## North Carolina Department of Transportation

## NEPA/SEPA Consultation Form

STIP Project No.	<u>B-5989</u>
WBS Element	<u>47845.1.1</u>
Federal Aid Project No.	<u>BRZ-1395(007)</u>

C. Changes in Proposed Action & Environmental Consequences:

PROJECT REFERENCE NO.	SHEET NO.
B-5989	5
RW SHEET NO.	
ROADWAY DESIGN ENGINEER	HYDRAULICS ENGINEER

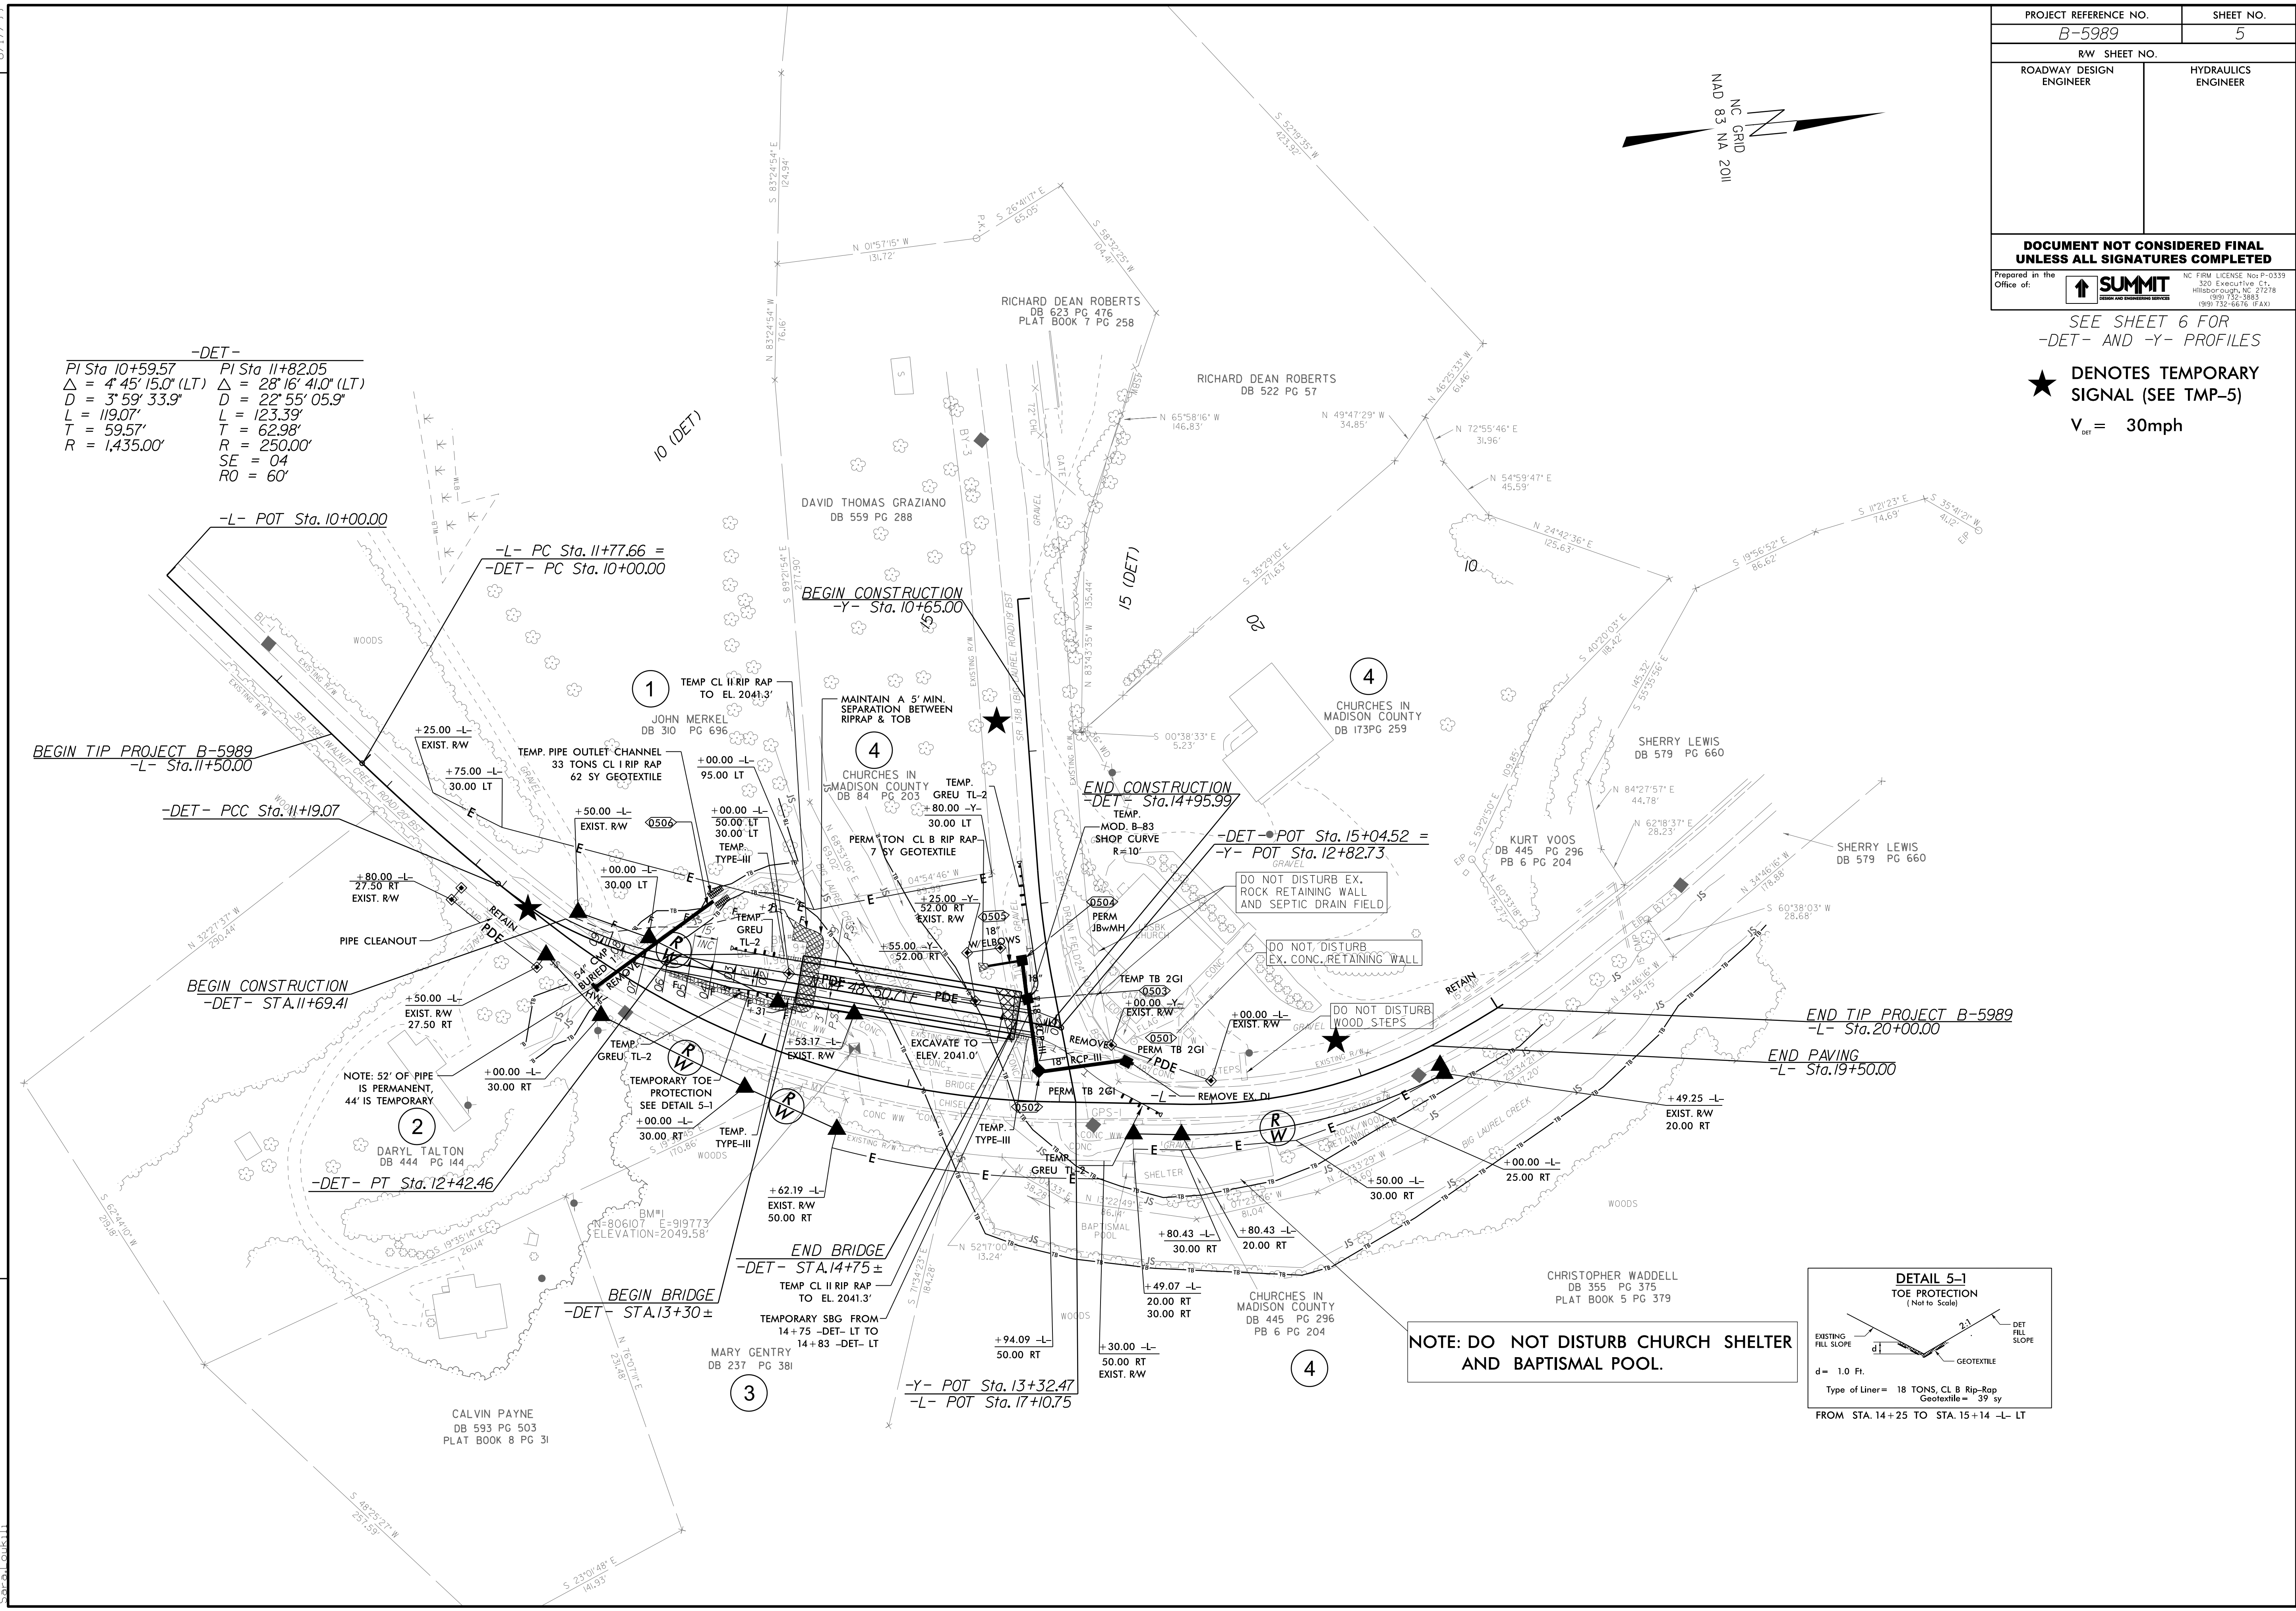
The proposed alignment for the roadway approach to the temporary on-site detour bridge has been shifted slightly during the development of the final designs. This shift in alignment resulted in a slight increase in the anticipated impacts to a perennial tributary of Big Laurel Creek (Stream SA). Additional stream impacts are a result of a new corrugated metal pipe being installed under Walnut Creek Road and the temporary detour alignment. Because of the roadway alignment shift, the proposed pipe increased in length by 6 feet, resulting in an increase from 47 feet to 52 feet in anticipated permanent jurisdictional stream impacts.
